**EPA Superfund  
Explanation of Significant Differences:**

**TRACY DEFENSE DEPOT (USARMY)  
EPA ID: CA4971520834  
OU 01  
TRACY, CA  
09/27/2004**

**2004 EXPLANATION OF SIGNIFICANT DIFFERENCES TO THE  
SITEWIDE COMPREHENSIVE RECORD OF DECISION  
DDJC-TRACY**

September 2004

Figure 6-1. Aggregate Cover and Soil Sampling Results, DSERTS 67, DDJC-Tracy

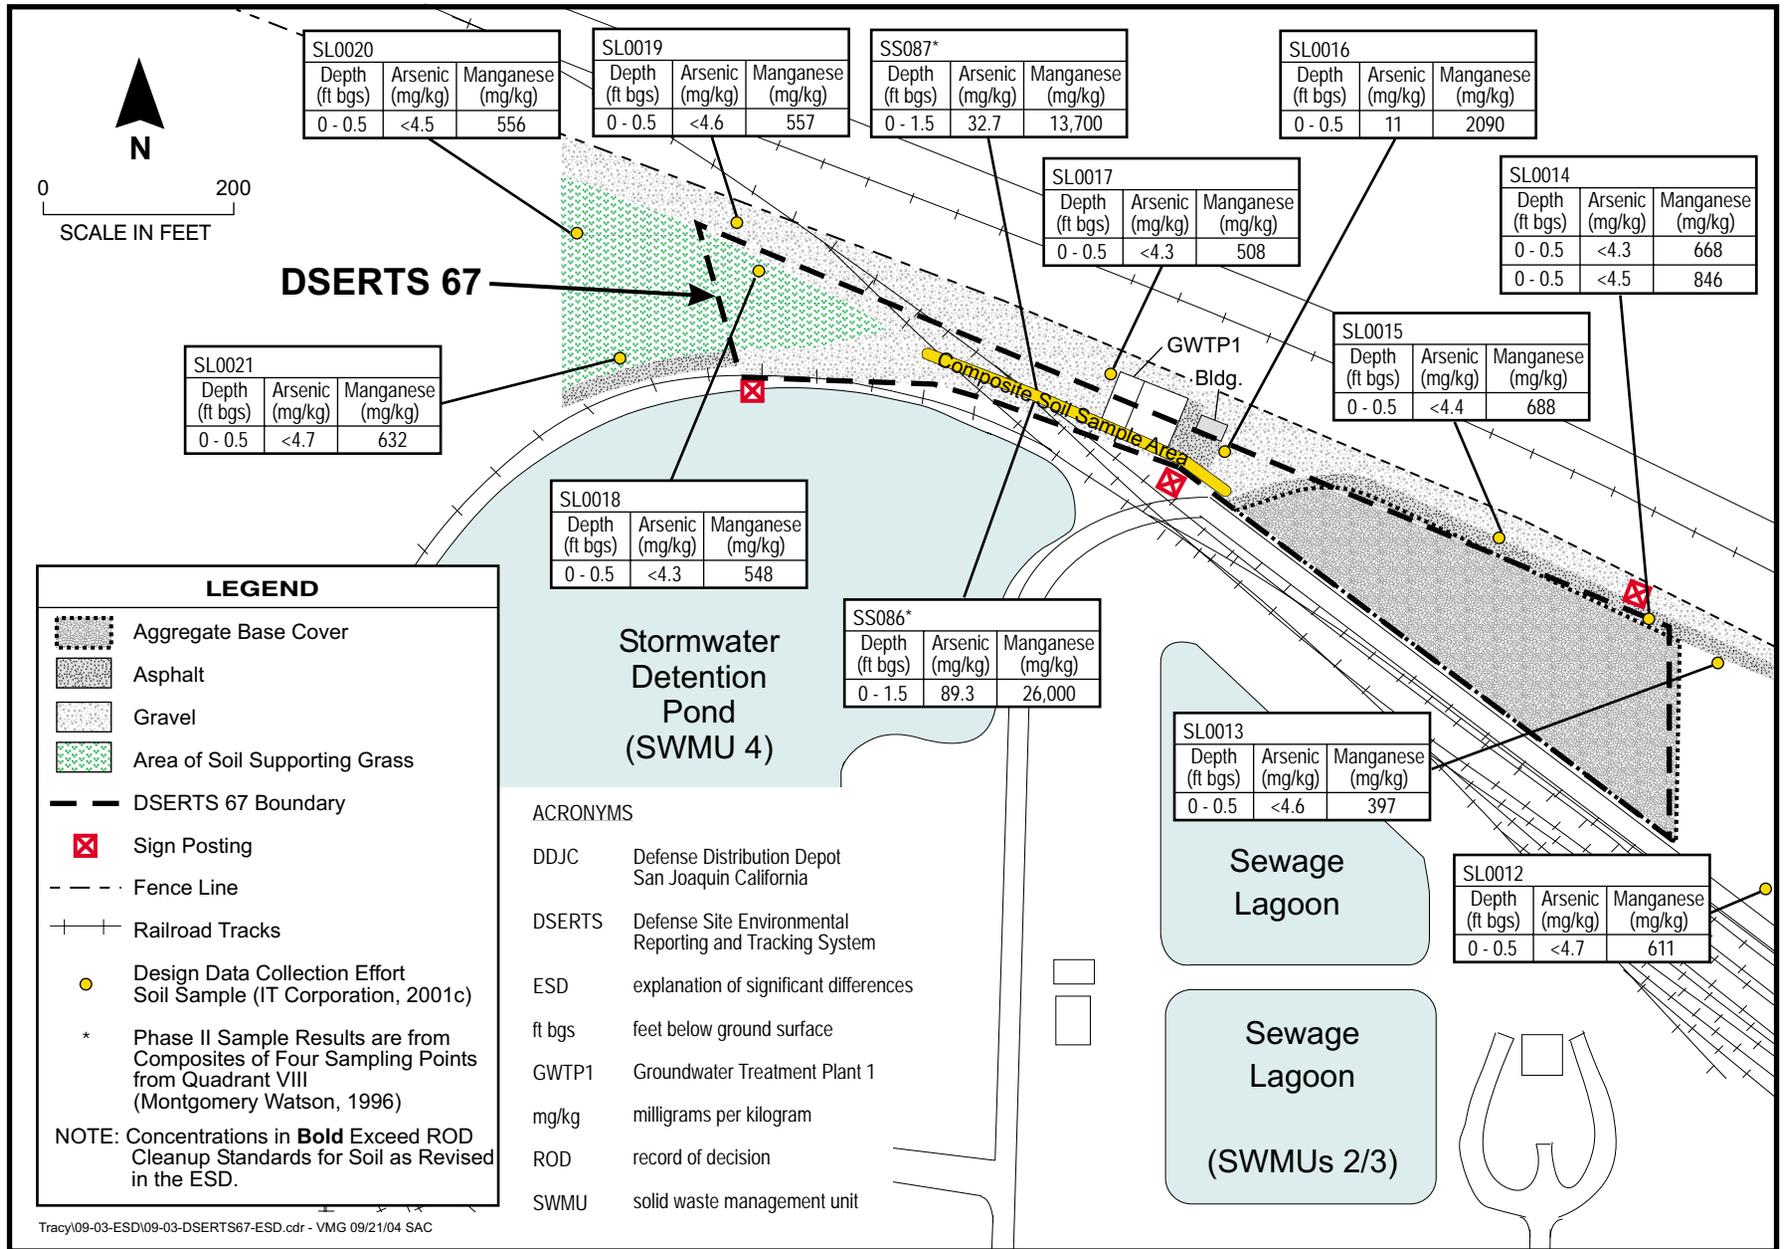
**6.2.1** The approximate size for the cover at DSERTS 67 (138,000 square feet) stated in the ROD was a rough approximation made without survey data. A survey of the DSERTS 67 area was conducted on 14 May 2003. The total area of the DSERTS 67 area, as delineated in Figure 9-12 of the ROD, actually measured 101,200 square feet.

**6.2.3** The AB, gravel, asphalt, and GWTP1 facility cover 88% of the DSERTS 67 area. The covers and structures are effective in protecting human health and satisfy the RAO in the ROD. The grass area in the northwestern portion of DSERTS 67, if disturbed, may provide an exposure pathway to surface and near-surface soil with concentrations of manganese and arsenic that exceed the cleanup standards.

**6.2.4** The grass area in the northwestern portion of DSERTS 67 is approximately 12% of the total area of DSERTS 67 and does not have an aggregate cover in accordance with ROD requirements. Soil in this area may have concentrations of arsenic and manganese exceeding the cleanup standard, although one sample (SL0018) collected within the grass area of DSERTS 67 had concentrations of arsenic and manganese below cleanup standards (Figure 6-1). The grass area is inaccessible to grading equipment, and a warning sign will be installed to discourage dust-generating activities. No threat to groundwater was identified in the ROD for DSERTS 67, and the area was not considered habitat for ecological receptors in the Baseline Risk Assessment (Montgomery Watson, 1997b). Residual contamination does not pose a threat to the environment.
